## Product Change Notification

1. ECN #: 243151

- USBR-B-S-X-O-SM-XX - null

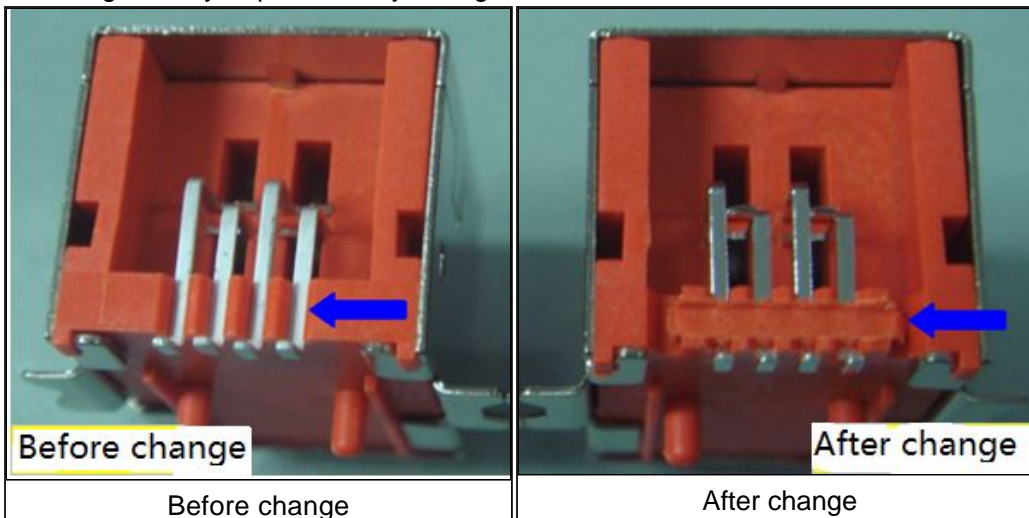
Add heat stake process to secure surface mount tails.

Backed geometry of plastic body changed as shown.

Improve Co-planarity of surface mount tails.

- Form - Geometry of the backend plastic body has changed due to the heat stake process.
